PALISADES PLANT

AMENDMENT TO FACILITY OPERATING LICENSE

Amendment No. 143  
License No. DPR-20

ATTACHMENT TO LICENSE AMENDMENT NO. 143

**FIGURE 3-0**

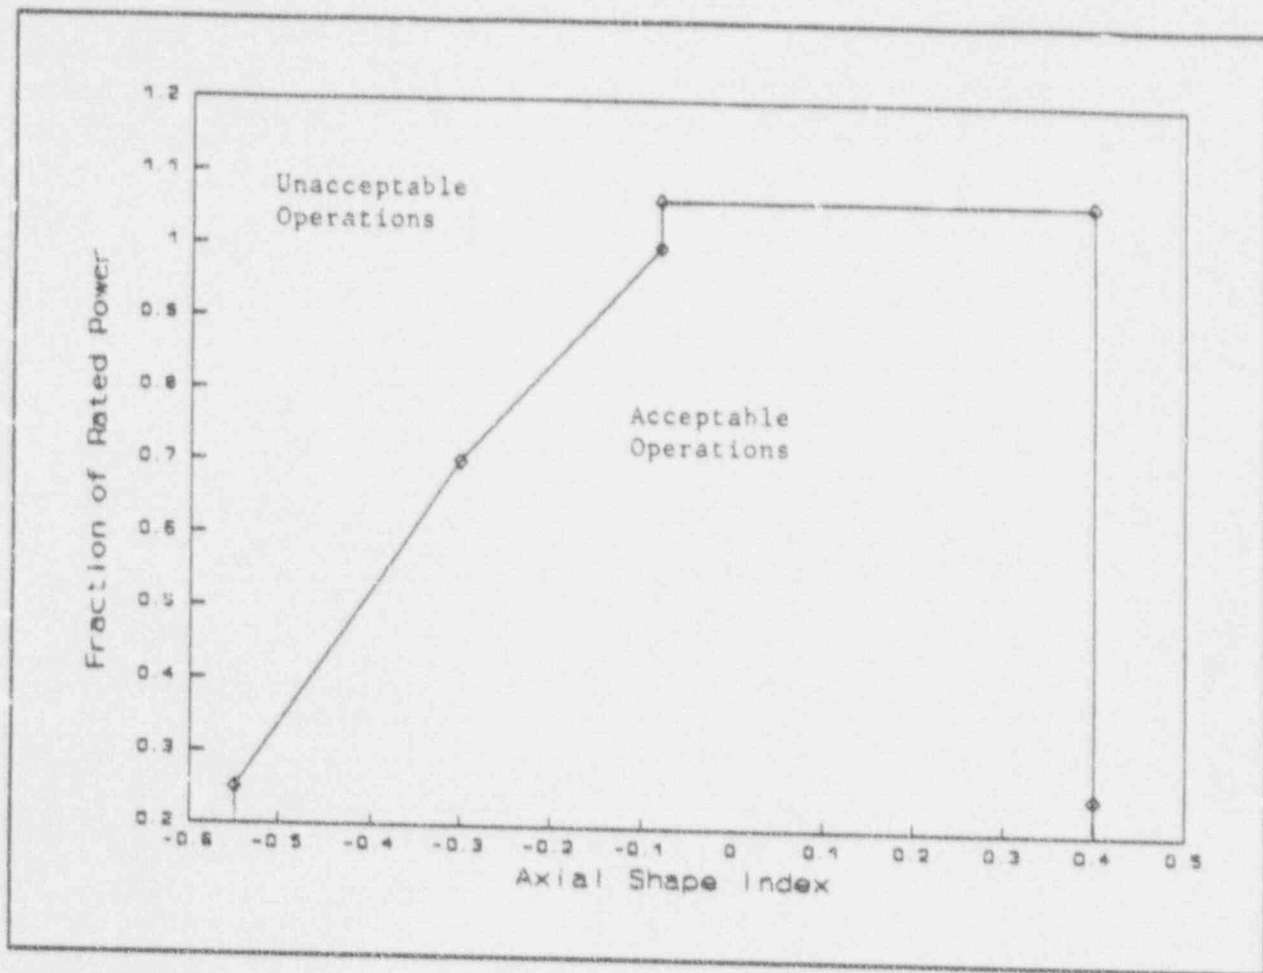
## ASI Limit for $T_{inlet}$ function

Break Points:

- 0.550, 0.250
- 0.300, 0.700
- 0.080, 1.000
- 0.080, 1.065
- +0.400, 1.065
- +0.400, 0.250
